CASE: PPT220050
EXHIBIT: A
DATE: 03.09.2023
PLANNER: R Brady
☑ Monthly ☐ Consent Agenda ☐ Time

Project:
CAJALCO & SEATON
County of Riverside, CA

Title: OVERALL SITE PLAN

Sheet: DAB-A1.1

OVERALL SITE PLAN (A)
scale: 1"=80'-0"

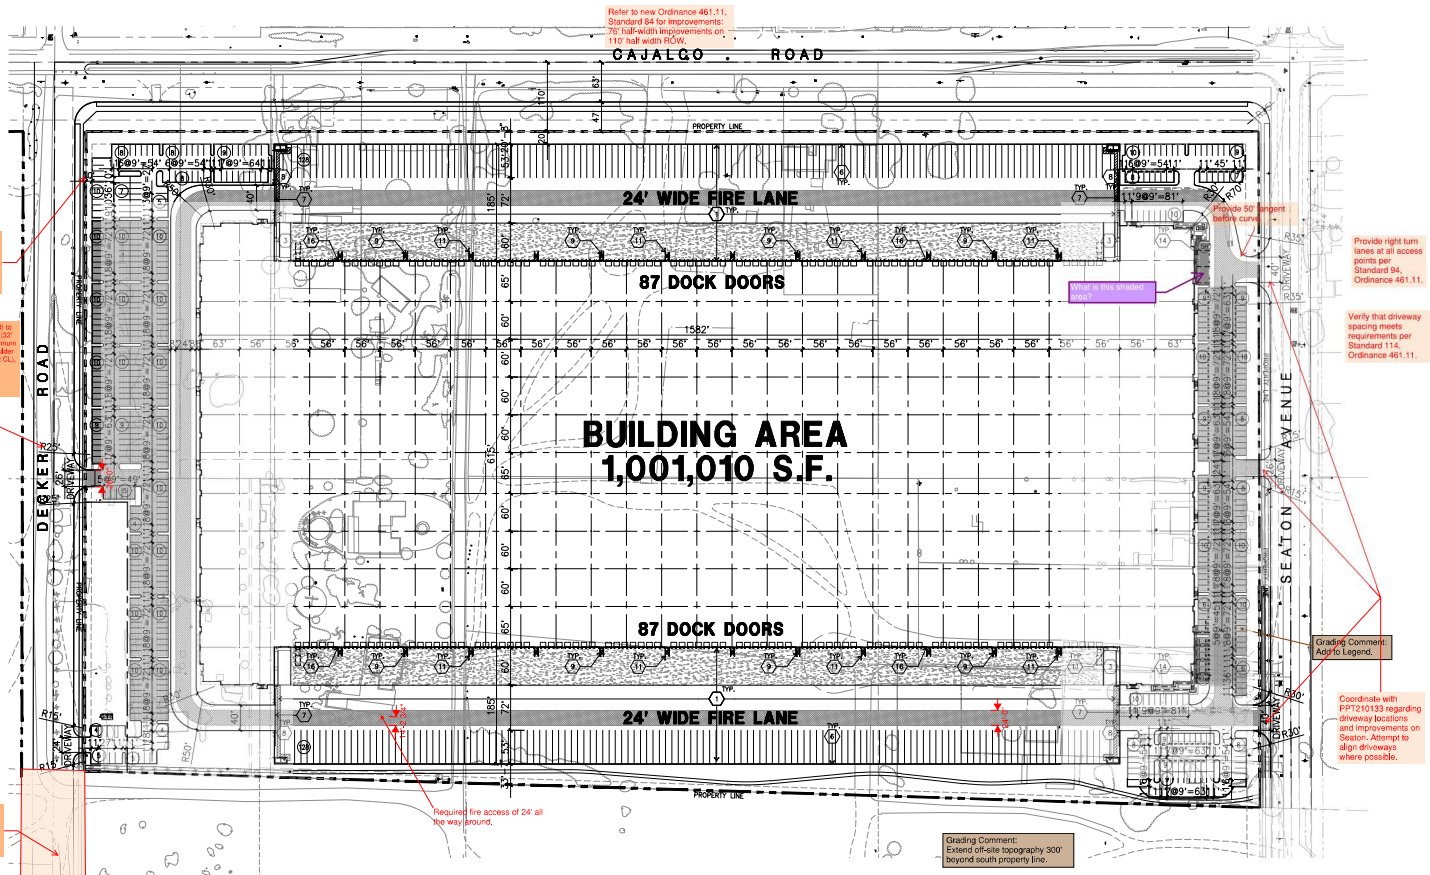
NOTE:
TRUCK CIRCULATION OFF-SITE TO AND FROM FREEWAY SHOULD ALSO DISCOURAGE USE OF SEATON TO THE SOUTH THAT WOULD CIRCULATE PAST RESIDENTIAL AREAS. SIGNAGE WOULD BE EXPECTED AT MINIMAL, BUT OTHER DESIGN FEATURES TO DISCOURAGE OR PREVENT TRUCK ACCESING SOUTH ON SEATON MAY BE APPROPRIATE.

Grading Comments:
1)Provide a conceptual grading and drainage plan.
2)Provide existing topography (include contour line elevations).
3)Include pad and finish floor elevations.

4)All manufactured slopes shall be shown as YYYY with the top of Y indicating top of slope and single leg of Y as toe of slope.
5)Provide Spot Elevations (proposed finish surface elevations) sufficient to demonstrate the streets, driveways, and drainage grades meet minimum requirements. Spot elevations should be provided at street intersections; cul-de-sac ends; beginning and end of driveways and all grade breaks.

6)Indicate the surface type of the parking areas, such as asphalt or concrete, etc. Keep in mind minimum surface grades are .35% for concrete and 1% for all other surface types, except for water quality features.

7)If proposing walls: Identify wall types (garden or retaining). Provide typical sections with maximum retaining wall heights and total wall heights – includes any wall or fencing atop the retaining wall.

8)If a Water Quality Management Plan (WQMP) is required, please show location of all water quality BMPs and point of discharge per WQMP.

Include typical sections on this exhibit as well.

Provide TIA and VMT for the project.

Provide a Truck Turning template for onsite circulation and truck route from proposed driveways to the intersections

Comments on provided on the Grading and drainage exhibit that are in the WQMP report. Submit a separate grading and drainage exhibit for the development review.

Provide a striping exhibit along exterior streets to be part of the truck turning template.

Coordinate with Planning on trails requirements.
